**PLANNED UNIT DEVELOPMENT
STAFF REPORT****Date: February 1, 2018****DEVELOPMENT NAME**

Kola Mobile, LLC

LOCATION3673 & 3679 Airport Boulevard
(South side of Airport Boulevard, 416'± East of Montlimar Drive).**CITY COUNCIL
DISTRICT**

Planned Unit Development Approval to amend a previously approved Planned Unit Development to allow an expansion of an existing restaurant for a development with shared parking and access between multiple building sites.

SITE PLAN

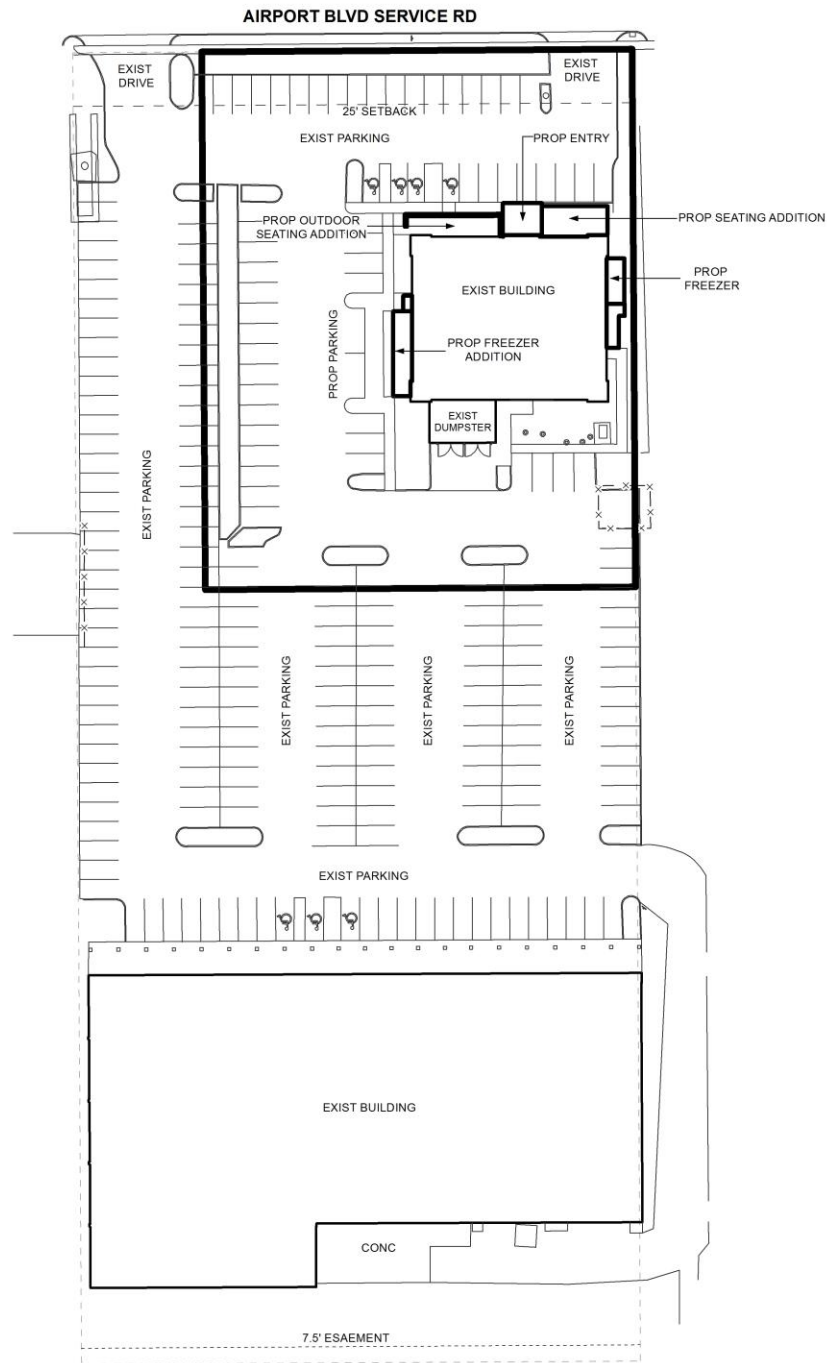
The site is currently developed with a vacant building that was previously a dine-in restaurant, and another multi-tenant building that consist of a pool hall/ lounge, and possibly one other active business. The site plan provided depicts a 32,869 square foot retail building however there is no information provided identifying each tenant space, the use of the space, and the square footage of each space. The lack of tenant and square feet information means that staff cannot determine if the parking depicted is sufficient for the overall development.

The site fronts the service road for Airport Boulevard, a major street with curb and gutter with what appears to be an adequate right-of-way. The site plan should however be revised to depict the actual right-of-way width.

The applicant is planning to make renovations to the vacant building to accommodate the new dine-in restaurant. The applicant plans to add two exterior coolers, a seating addition on the front of the building, a new exterior entry structure, and exterior sitting areas. The site plan does not clearly distinguish the square footage and the outdoor seating, which will impact parking requirements. By adding additional seating the applicant will be increasing the building foot print by an estimated 410 square feet. The estimated total square footage for the new restaurant building will be 7,466 square feet. The site plan indicates that the current total square footage for all buildings in the PUD is 39,925 square feet and the proposed square footage with renovations will be 40,335 square feet for all buildings located within the PUD. The site plan should be revised to depict the square footage and outdoor seating space.

In regards to parking spaces, the site analysis box depicted on the site plan illustrates 235 parking spaces. The site plan also illustrates that the restaurant is 7,466 square feet thus requiring 75 parking spaces and the remainder of the site as retail making up 32,869 square feet with 110 parking spaces. The site analysis is incorrect because it depicts the 32,869 retail space to the wrong parking ratio; therefore the calculations are incorrect. Although the total amount of required parking spaces appears to remain sufficient staff, will need a revised site plan depicting each unit space in the multi-tenant building and the use of each space to properly determine parking calculations.

It should be pointed out that the subject property has a 10' water and sewer easement within the 25' minimum building setback. A note should be placed on the site plan stating no structures shall be constructed or placed in any easements.

The revised site plan should be detailed and clearly identify the changes and proposed revocations and additions to the site.

- 1) submission of a revised site plan that depicts the overall site including the proposed restaurant and the multi-tenant building, identifying each tenant space, the use of the space, and the square footage of each space;
- 2) revision of the site plan to depict the right-of-way width along Airport Boulevard Service Road; and
- 3) revision of the site analysis information to be in compliance with Section 64-6 of the Zoning Ordinance regarding off street parking ratios.
